Modification of the St. Louis Class B Airspace Area; MO

ACTION: Final rule; correction.

Airspace Docket No. 03–AWA–2, FAA Docket No. FAA–2005–22509. In that rule, inadvertent errors were made in the graphic depicting the modified St. Louis Class B airspace area. This action corrects those errors.

ST. LOUIS, MO CLASS B AIRSPACE AREA

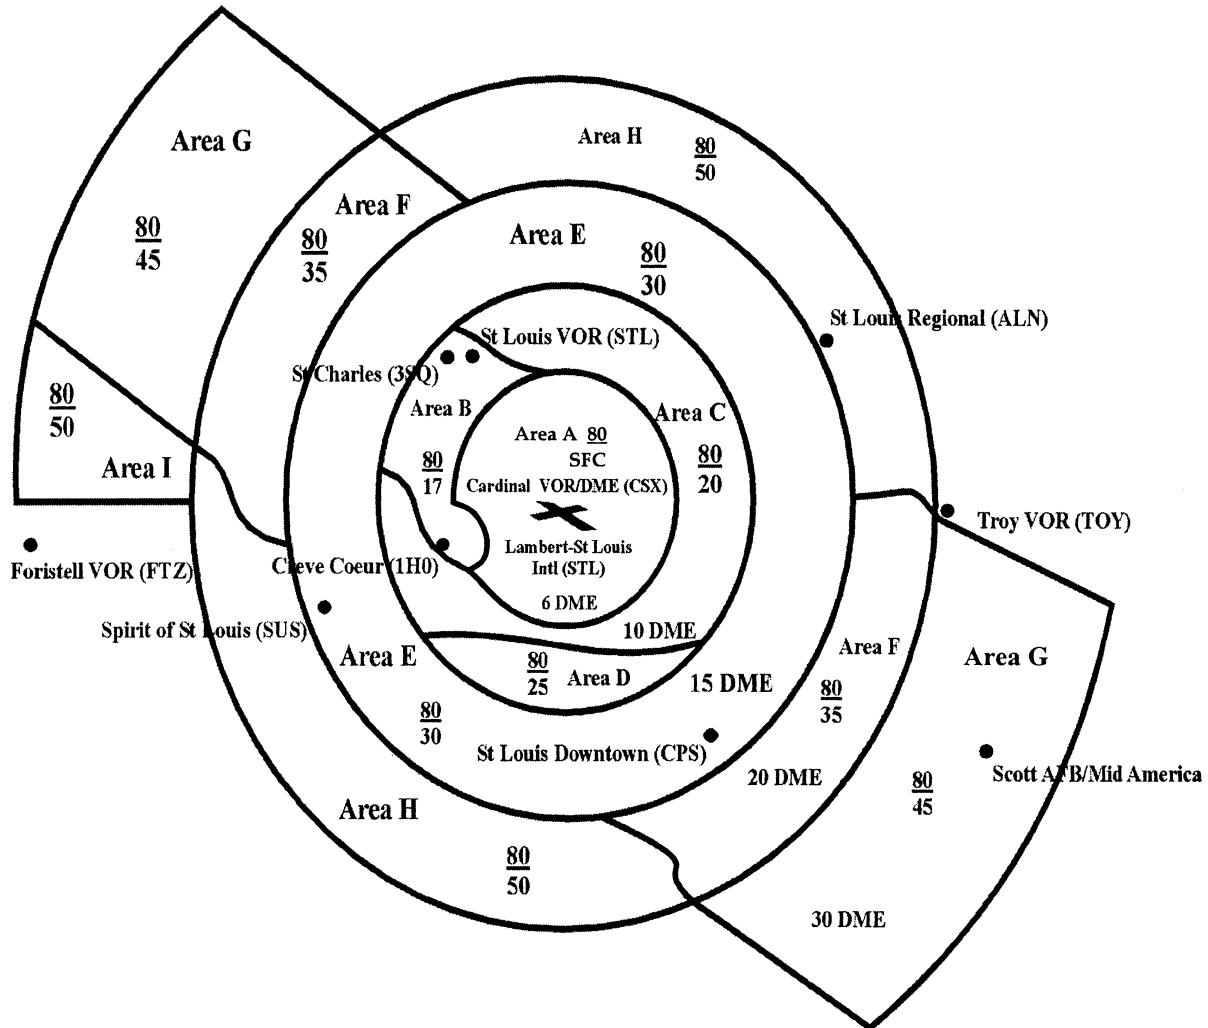
On February 15, 2006, a final rule was published in the **Federal Register** modifying the St. Louis Class B airspace area (71 FR 7848), Airspace Docket No. 03-AWA-2, FAA Docket No. FAA-2005-22509. In that final rule, inadvertent errors were made in area A of the attached graphic of the St. Louis Class B airspace area. Specifically, the altitudes for Area A were depicted as extending from the surface to and including 5,000 feet MSL (50/SFC) rather than from the surface to and

including 8,000 feet MSL (80/SFC). Also, the 1.5 NM radius exclusion around Creve Coeur Airport was not depicted. This action replaces the graphic reflecting the correct altitudes for area A and the exclusion around the Creve Coeur Airport.

■ On page 7851, Area A, delete the graphic of the St. Louis, MO Class B Airspace Area, and insert the corrected graphic.
